Access Compliance Report

Public Rights-of-Way

(Curb Ramps)

Intersection ID: 21509	Main Street: COVEDALE_DR	Cross Street: SARDIS_RD_NORTH	Location: NE
ADA ID: 979443223D36	Ramp Type: PerpDiag	Initial Pass/Fail: Fail	Overall Compliance: No
		Severity Score: 13.75

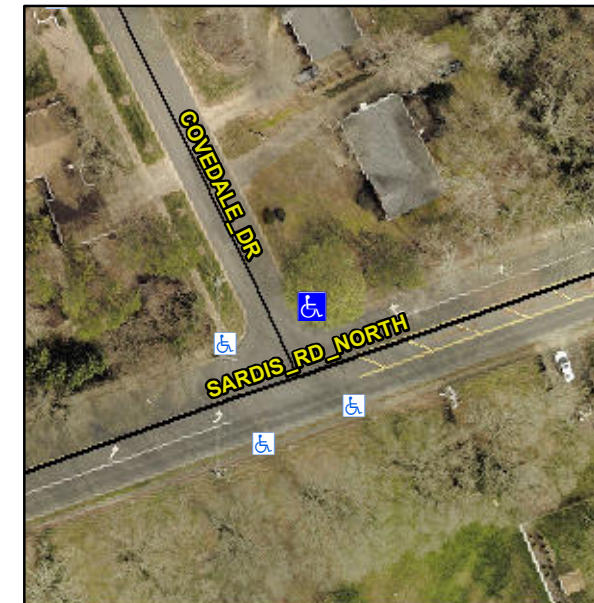
Not Found, R304.2.2, R304.5.3

Compliance	Description	Data	Compliance	Description	Data
N/A	Ramp Length (in)	28.0	No	Ramp Slope (%)	10.2
Yes	Ramp Width (in)	48.0	No	Ramp XSlope (%)	4.8
N/A	Flare Type LT	N/A	N/A	Flare Type RT	N/A
N/A	Flare Slope LT (%)	N/A	N/A	Flare Slope RT (%)	N/A
N/A	Flare Traversable LT?	N/A	N/A	Flare Traversable RT?	N/A
N/A	Landing Length (in)	N/A	N/A	DWS Provided?	N/A
N/A	Landing Width (in)	N/A	N/A	DWS Contrast?	N/A
N/A	Landing Slope (%)	N/A	N/A	DWS Length (in)	N/A
N/A	Landing X Slope (%)	N/A	N/A	DWS Full Width?	N/A
N/A	Landing Curb? (Y/N)	N/A	N/A	DWS Offset (in)	N/A
N/A	Shared Landing?	N/A			
N/A	Gutter Ponding?	N/A	N/A	Gutter Slope (%)	N/A
N/A	Gutter Lip Ht (in)	N/A	N/A	Gutter X Slope (%)	N/A
N/A	Painted X Walk1?	No	N/A	Painted X Walk2?	No
	X Walk 1 Direction	To W		X Walk 2 Direction	To S
N/A	X Walk 1 Width (in)	N/A	N/A	X Walk 2 Width (in)	N/A
	X Walk 1 Slope (%)	6.7		X Walk 2 Slope (%)	5.4
	X Walk 1 X Slope (%)	2.4		X Walk 2 X Slope (%)	2.1

Remove & Replace Curb Ramp With Two New Directional Ramps or Equivalent.
